**Amendment to the Drawings:**

## **REMARKS/ARGUMENTS**

Fig. 5

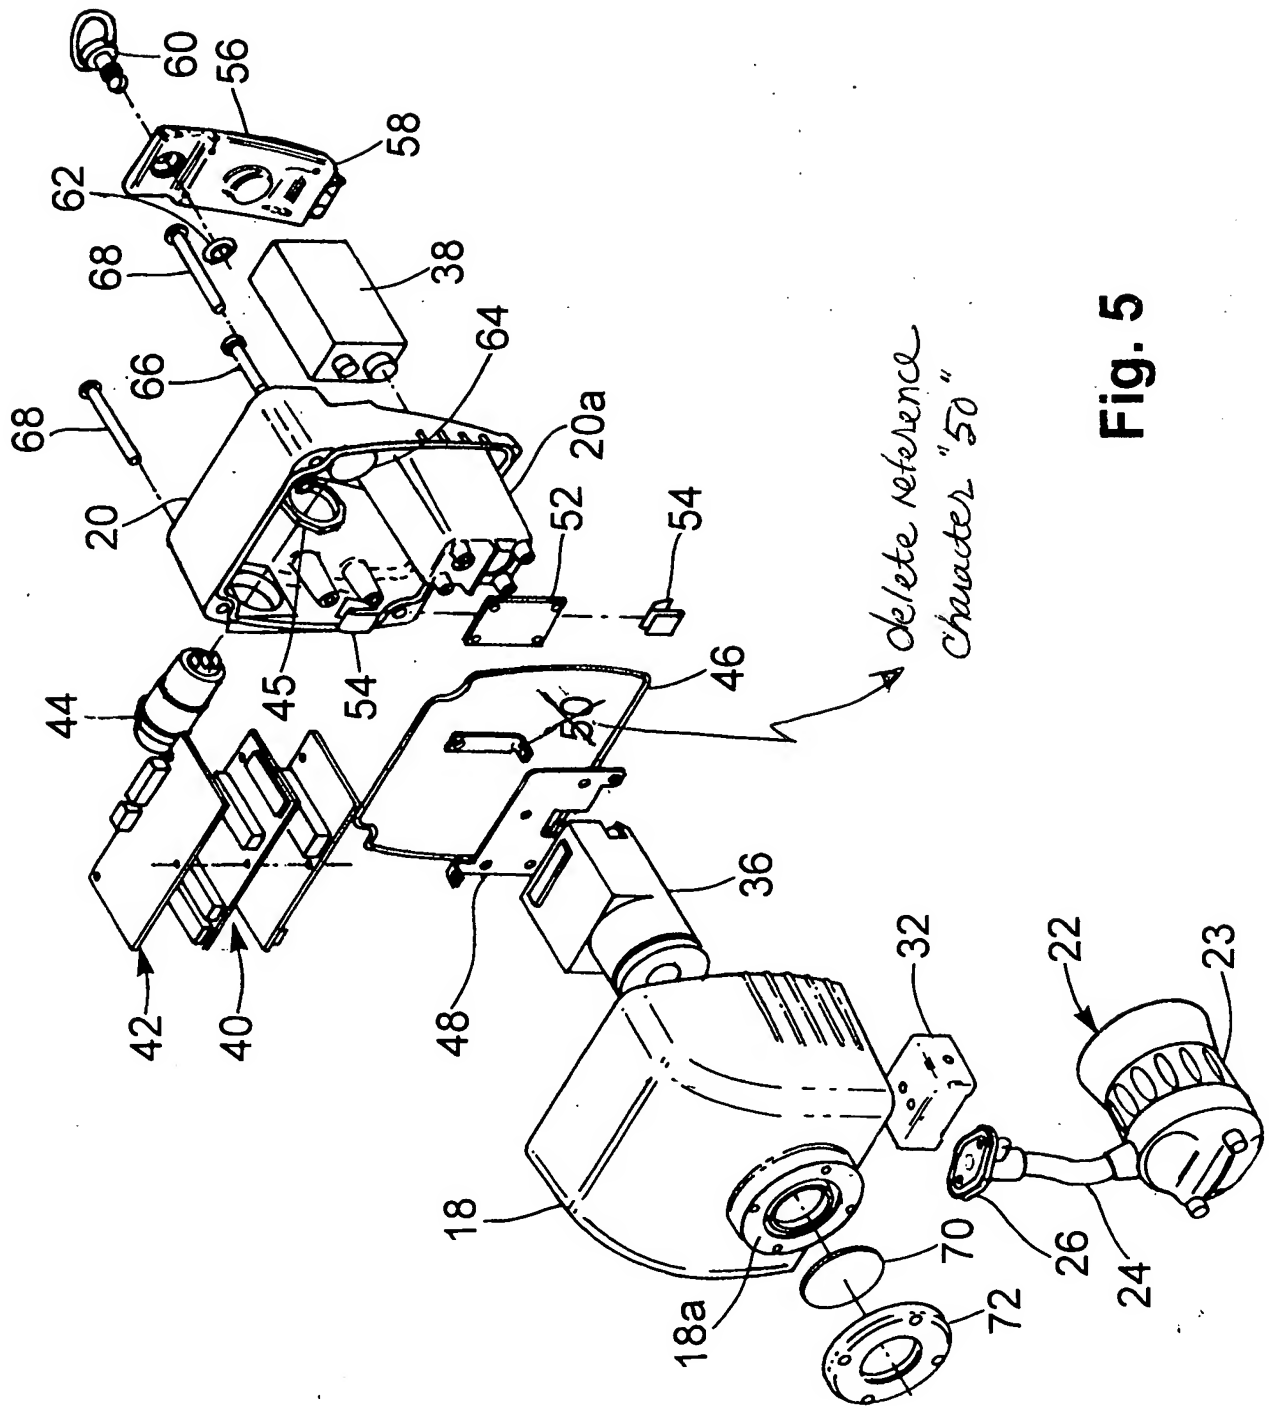
The drawings, particularly Fig. 5, were further objected to by the Examiner for failing to comply with 37 CFR 1.84(p)(5), in this case for designating the reference character "50" not mentioned in the description. Applicants acknowledge this non-compliance and have accordingly amended Fig. 5 to remove the unnecessary reference character. A proper "Replacement Sheet" for Fig. 5 as well as an annotated sheet indicating the corrective action are submitted herewith in compliance with 37 CFR 1.121(d), and the objection to the drawings should now be removed.

The attached drawing sheet of Fig. 5 includes a change made thereto and replaces the original drawing sheet of Fig. 5. In Fig. 5, the reference character “50”, not mentioned in the description, has been deleted, as is indicated in the annotated drawing sheet further attached.
